Site Instruction

SI 24

PROJECT : Hampton Manor
PROJECT No : 1136.13
DATE : August 14, 2018

Title: Removal of Insulation behind Precast

SECTION DETAIL @ ROOF/PRECAST PANEL 6
SCALE - 1/5 A652

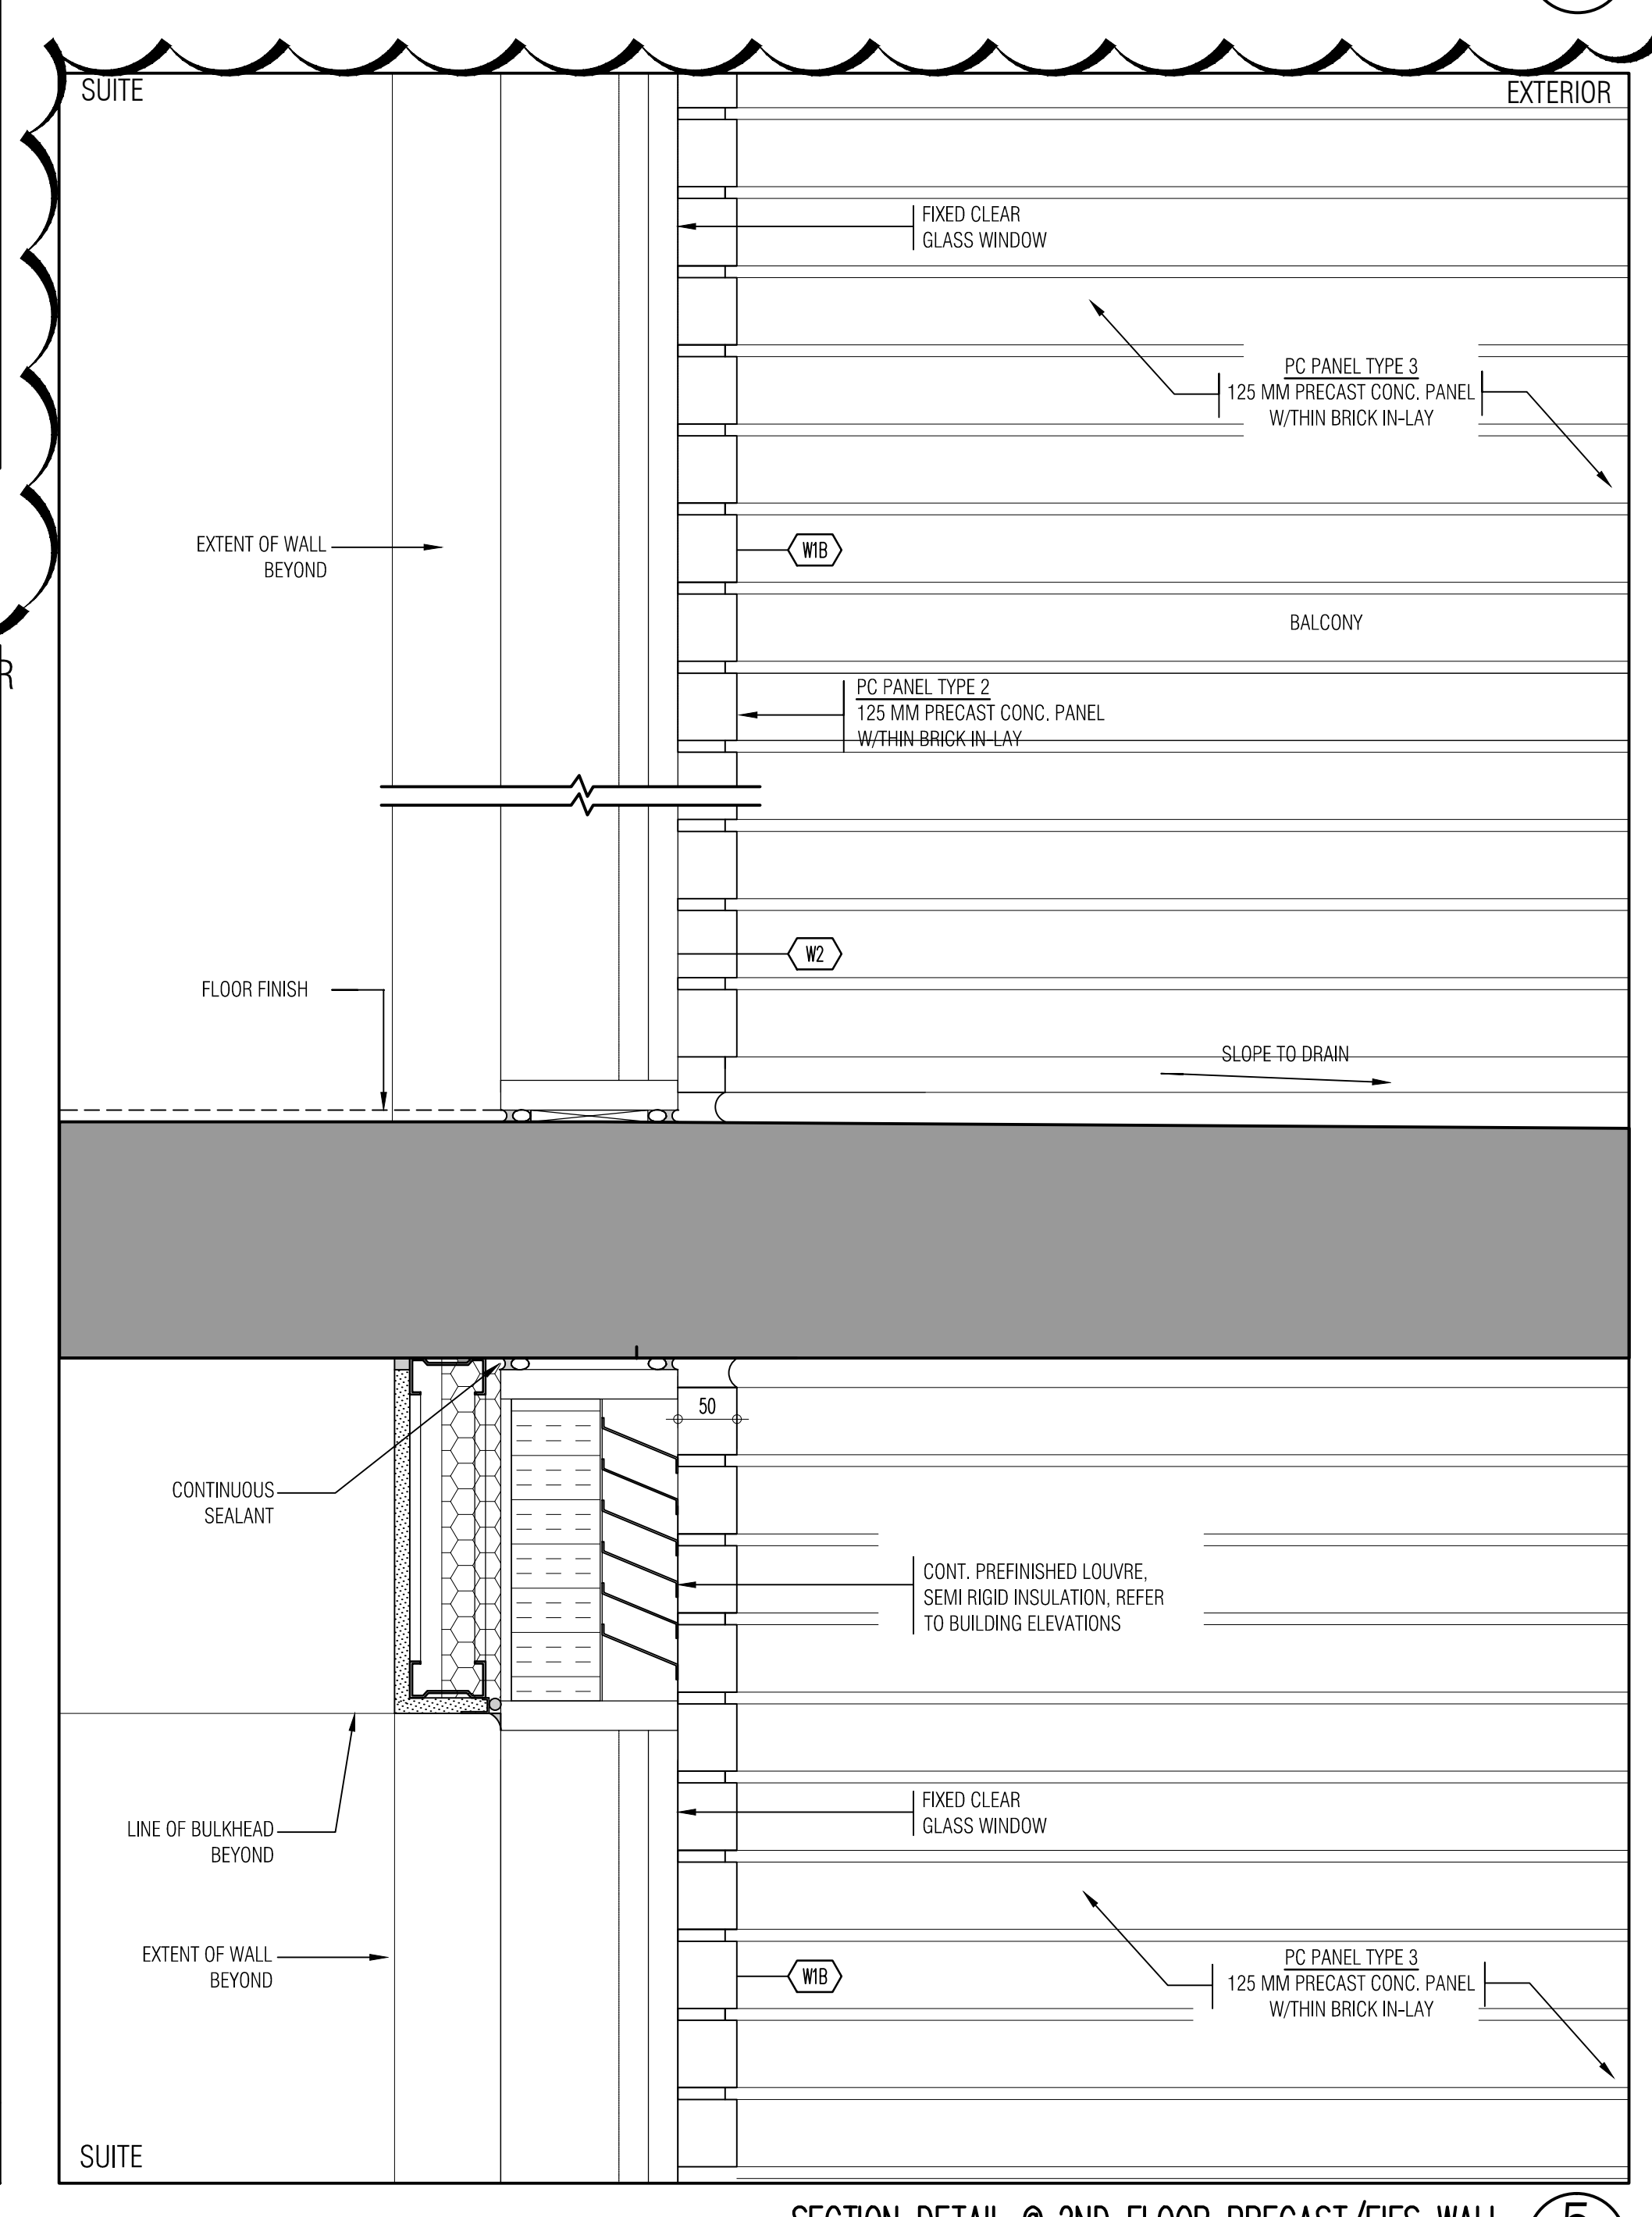
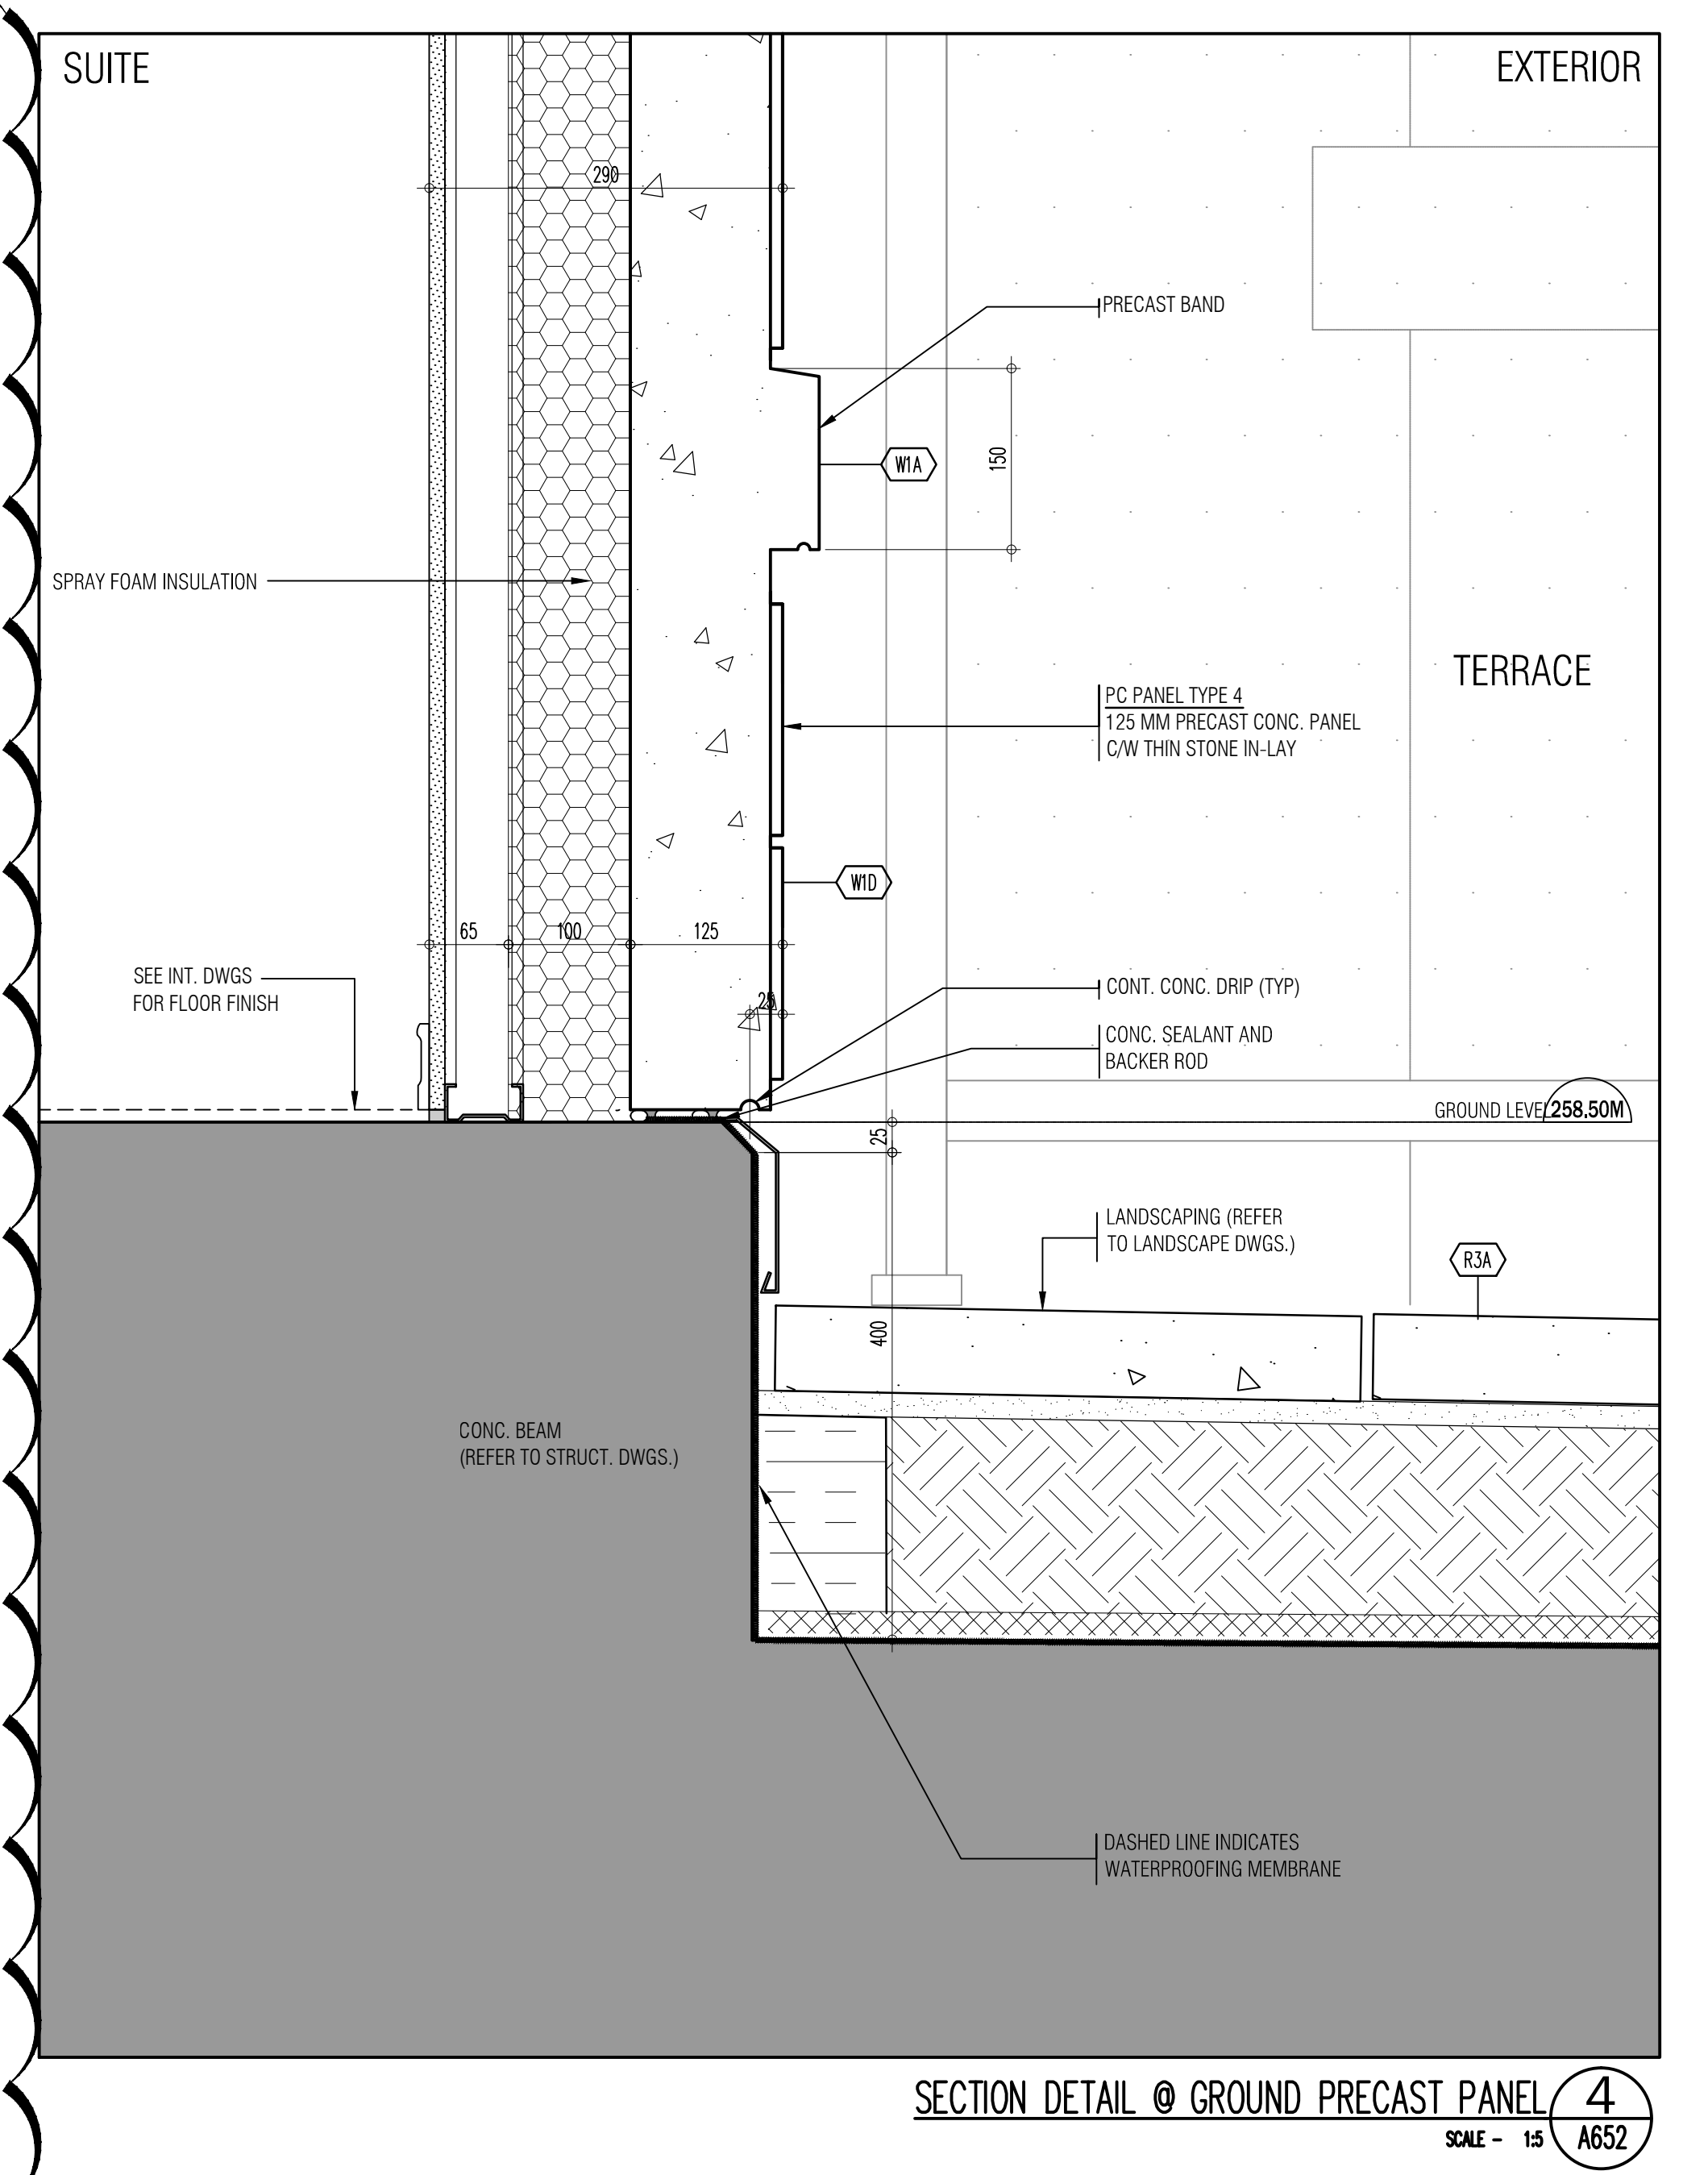
- Removal of insulation behind precast at terraces and roof.
